MONTGOMERY COUNTY HISTORIC PRESERVATION COMMISSION
STAFF REPORT

Address: 7307 Takoma Avenue, Takoma Park **Meeting Date:** 10/25/2023
Resource: Contributing Resource **Report Date:** 10/18/2023
 Takoma Park Historic District **Public Notice:** 10/11/2023
Applicant: Jeffrey Luker **Tax Credit:** No
 (Fusion Solar Service, Agent)
Review: HAWP **Staff:** John Liebertz

PROPOSAL: Solar panel installation.

Diagram 1: Irradiance map as captured in Aurora.

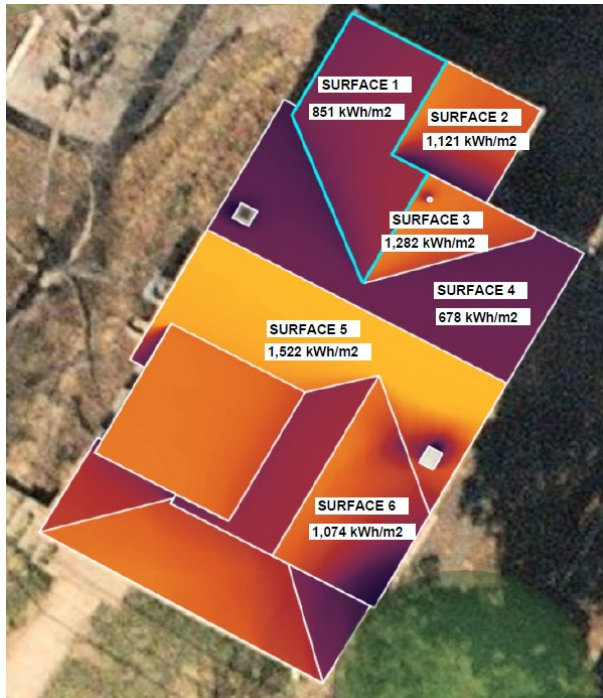
The third preferred location is a roof-mounted array on a non-historic addition of the main house. The applicant studied placing solar panels on the non-historic addition, but the solar irradiance and dimensions of the roofs of the rear gable addition prohibit the use of this location. As shown in *Figure 3*, the western slope (Surface 1) has a low solar irradiance and the eastern slope (Surface 2) only accommodates an array of two (2) panels. This would result in a disjointed, multi-roof solution and inefficient system.
